HOPEWELL RADIOLOGY GROUP, L.P.

**Re: License No. 29-20974-01**

This letter is being submitted to you to request certain amendments to our current NRC Byproduct Material License. Our current license, Amendment No. 14, dated May 13, 2005, due to expire on June 30, 2012, describes our current program. Please make the following changes to that document:

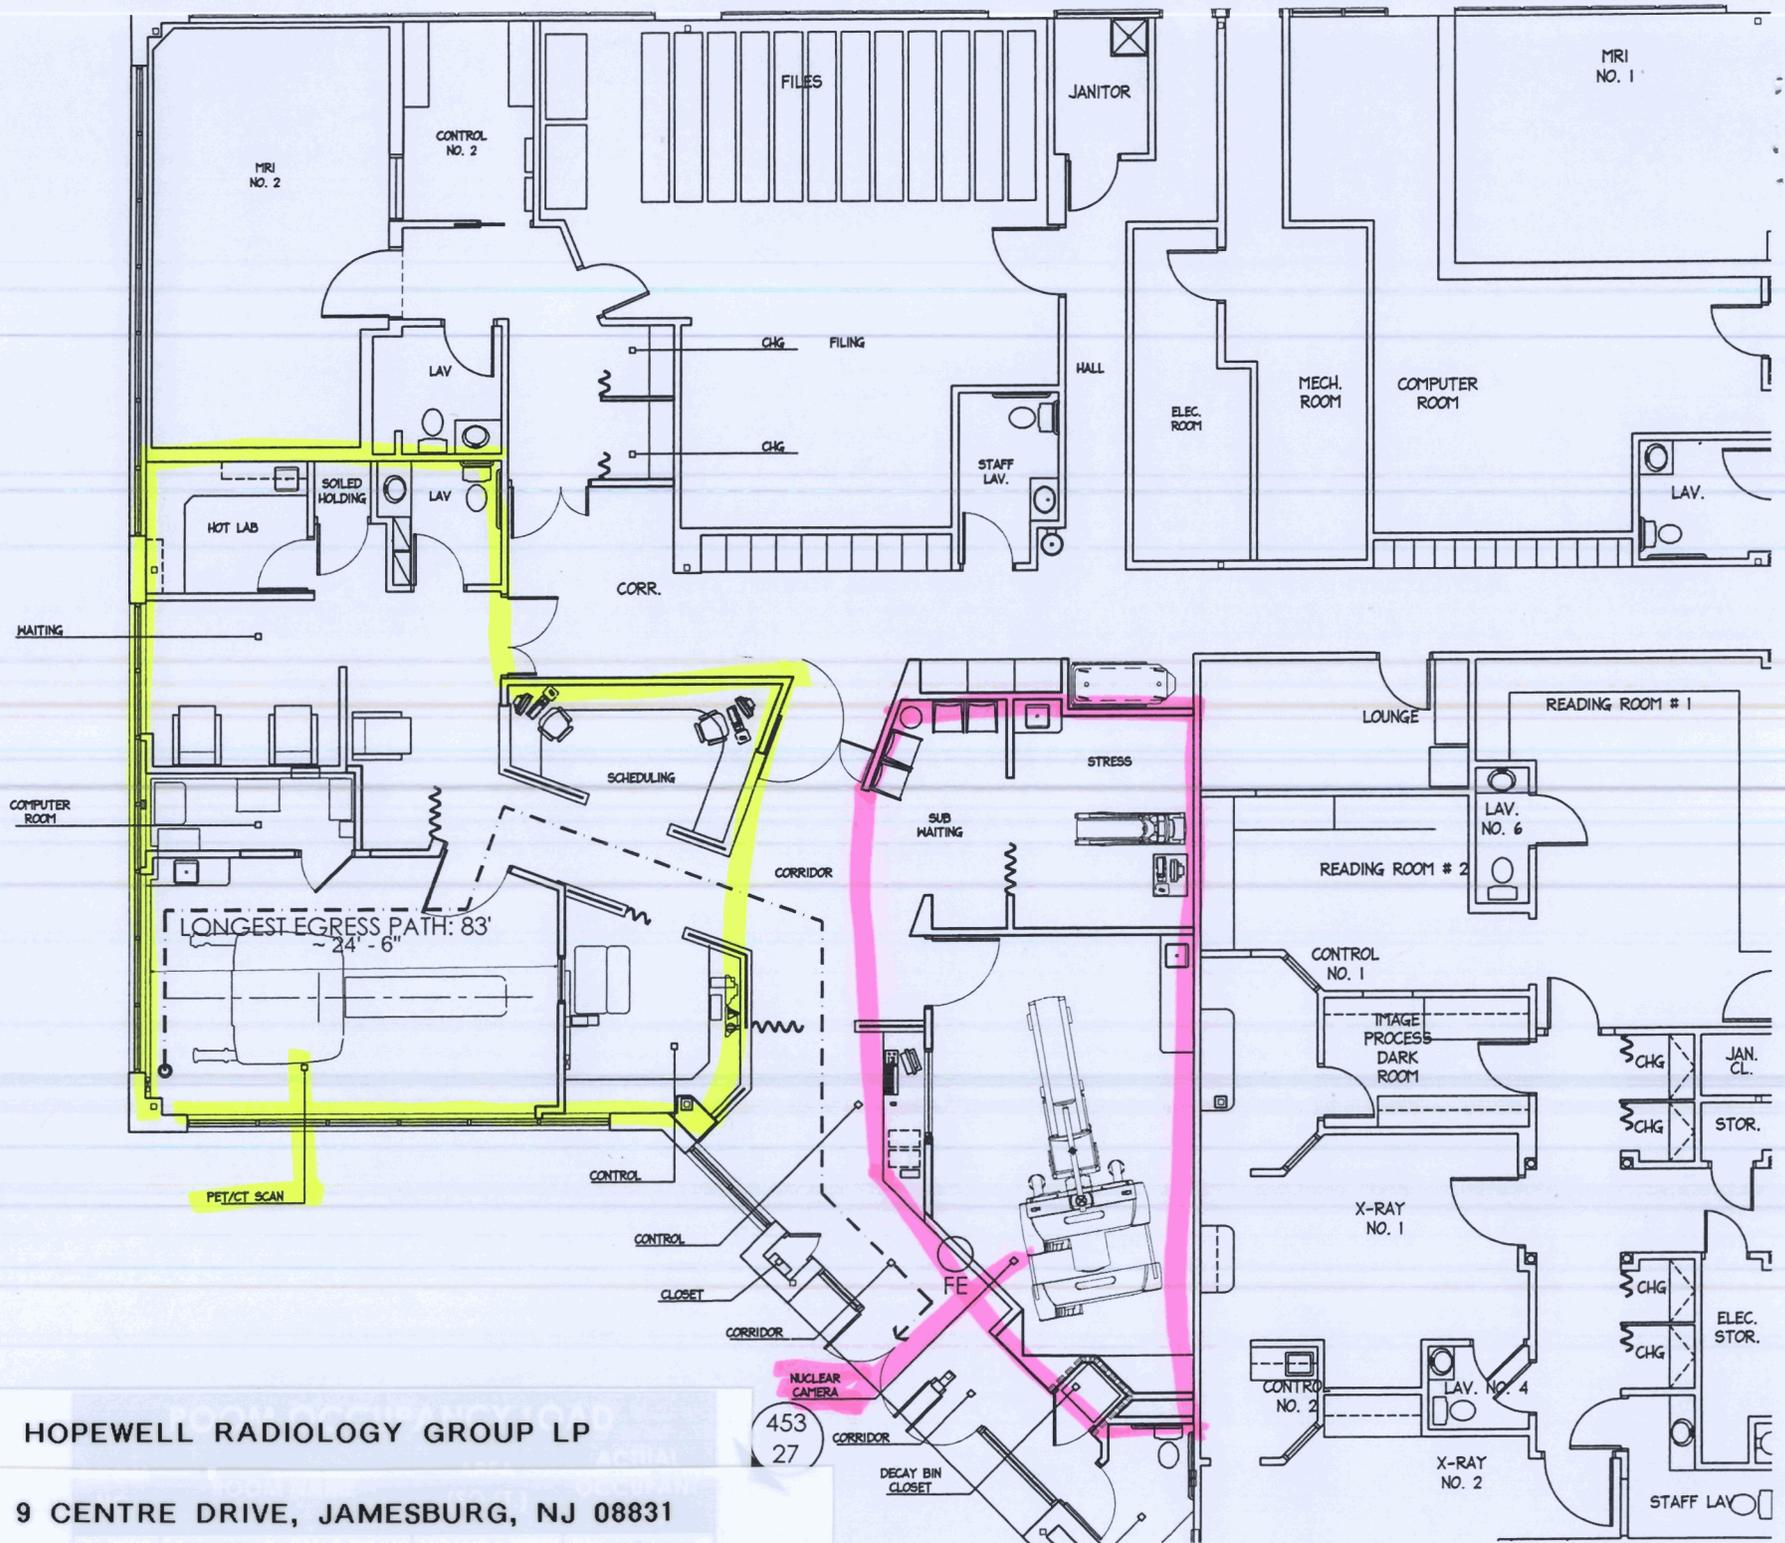
1. Delete Eric S. Perlman, MD as an authorized user under this license. Dr. Perlman has resigned from the group.
2. Delete Barry D. Julius, MD as an authorized user under this license. Dr. Julius has resigned from the group.
3. Certain changes have been made to the physical plant in our licensed facility at 9 Centre Drive, Jamesburg, New Jersey. Please refer to the enclosed floor plan of the Nuclear Medicine department. The area in yellow currently houses our PET scan equipment and the related hot lab. This area has been modified to increase the length of the scanner room to accommodate a PET/CT unit and to relocate the control area with respect to that room. No changes were made to the hot lab area.

The area outlined in pink will house a Siemens SPECT/CT camera to be acquired and installed on February 11, 2008. The radioactive materials utilized in the operation of this equipment will be stocked in the existing hot lab adjacent to the PET scan area. Additionally, the diagram describes the location of the decay bin that will be used in the department.
